TECHNICAL & SAFETY COMMITTEE

INTERNATIONAL PARACHUTING COMMISSION (FAI)

Technical & Safety Information Notice No.	01/2009	W.N. 22
Date of Issue	28 January 2009	
Subject Matter and Applicability	<p>Following a riser failure on a PA Talon, the Australian Parachute Federation's Director Rigging, Jo Chitty, issued the following notice. This notice is of mandatory status for APF members, and it is being distributed by the Technical & Safety Committee of IPC to alert skydivers worldwide to the issues concerned.</p> <hr/> <p style="text-align: center;">IMPORTANT ANNOUNCEMENT FROM THE DIRECTOR OF RIGGING, AUSTRALIAN PARACHUTE FEDERATION. MANDATORY INSPECTION OF ALL 3-RINGS PRIOR TO NEXT USE</p> <p>RISER FAILURE On Sunday 18 January 2009, a PA Talon riser failed on opening. It was the left riser with RSL fitted. The reserve was deployed into the trailing main by the RSL resulting in a main reserve entanglement. Fortunately and with luck the jumper managed to attain sufficient reserve inflation to survive the landing with broken bones in his back and shoulder.</p> <p>During the investigation of his equipment it was found that the 3-ring closing loop had pulled out from under the confluence

Typical view of locking loop length

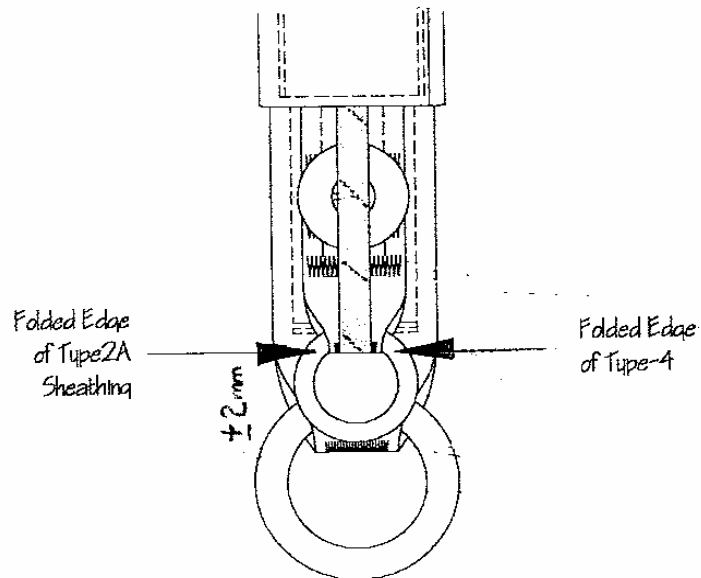
On all solo rigs and all types of riser style, one inch type 17 mini rings, type 8 mini rings and standard type 8 with the larger rings, the length of the locking loop should be level (+/- 2mm) with the end of the fold of the webbing that retains the small ring when the riser is laid flat with some tension applied to the small ring.

It is normal for new type 17 mini risers to be tight to interlock the rings, this is because they become more pliable with use, but the locking loop must still allow the housing some play and not pull the small ring against the riser, see side view on service bulletin.

MANDATORY INSPECTION in accordance with APF Service Bulletin [APF010801-B](#)* Issued 23rd January 2009 of all 3-ring riser assemblies before the next jump. Inspection to be noted on reserve packing card and marked on inside of front riser with APF010801-B using a fine tip paint pen so it will be visible even if the risers are black.
